MILITARY SPECIFICATION

INDICATOR, VERTICAL SPEED, 0-6000 FPM, 2-INCH

This amendment forms a part of Military Specification MIL-I-18804B, 22 June 1964, and is mandatory for use by all Departments and Agencies of the Department of Defense.

FIGURE 2. DIAL MARKINGS FOR MS28075-1 (B) and MS28075-2 (B)

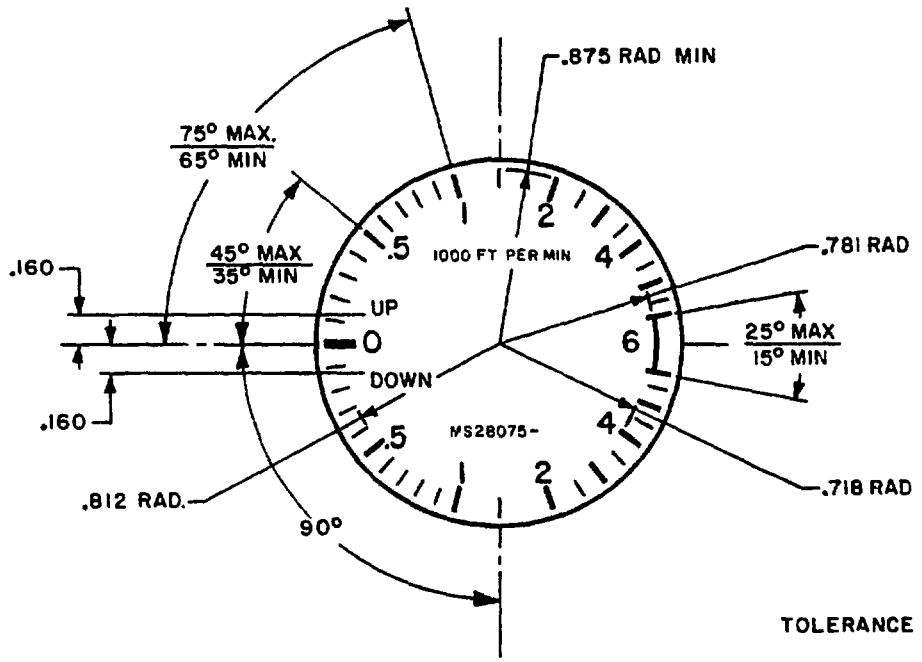
Add Figure 2 "Dial Markings for MS28075-1(B) and MS28075-2(B)" after Figure 1, page 6. Figure 2 forms page 3 of this Amendment.
